UNITED STATES PATENT AND TRADEMARK OFFICE

APPLICATION NO.	FILING DATE	FIRST NAMED INVENTOR	ATTORNEY DOCKET NO.	CONFIRMATION NO.
09/273,448	03/22/1999	SHINGO OHKAWA	1185.1044/JD	7146
21171	7590	06/13/2006	EXAMINER	
STAAS & HALSEY LLP SUITE 700 1201 NEW YORK AVENUE, N.W. WASHINGTON, DC 20005			NGO, HUYEN LE	
			ART UNIT	PAPER NUMBER
			2871

Office Action Summary

DETAILED ACTION

Fig. 2

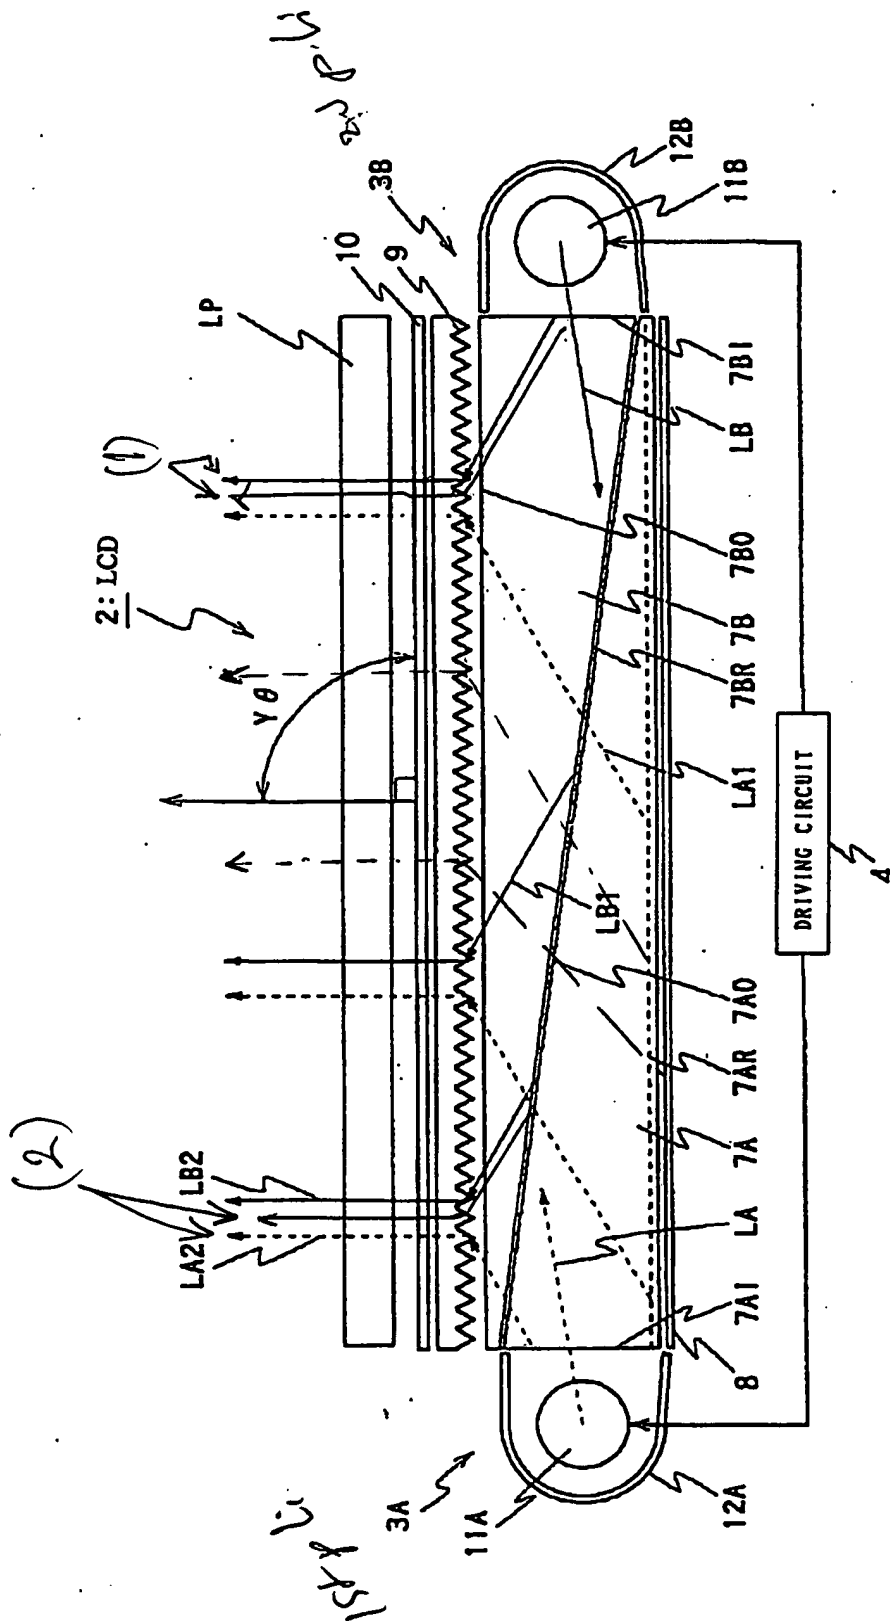
The drawings are objected to under 37 CFR 1.83(a). The drawings must show every feature of the invention specified in the claims. Therefore, the features recited in claim 13, "*the first slopes mainly receive light from said first primary light source and said second slopes mainly receive light from said second primary light source,*" must be shown or the feature(s) canceled from the claim(s). No new matter should be entered.

It appears from figure 2 that **both** first and second slopes receive light from the **same** light source (1), and the same slope receives light from different light sources (2). See Attached figure 2.

Corrected drawing sheets in compliance with 37 CFR 1.121(d) are required in reply to the Office action to avoid abandonment of the application. Any amended replacement-drawing sheet should include all of the figures appearing on the immediate prior version of the sheet, even if only one figure is being amended. The figure or figure number of an amended drawing should not be labeled as "amended." If a drawing figure is to be canceled, the appropriate figure must be removed from the replacement sheet, and where necessary, the remaining figures must be renumbered and appropriate changes made to the brief description of the several views of the drawings for consistency. Additional replacement sheets may be necessary to show the renumbering of the remaining figures. Each drawing sheet submitted after the filing date of an application must be labeled in the top margin as either "Replacement Sheet" or "New Sheet" pursuant to 37 CFR 1.121(d). If the examiner does not accept the changes, the applicant will be notified and informed of any required corrective action in the next Office action. The objection to the drawings will not be held in abeyance.
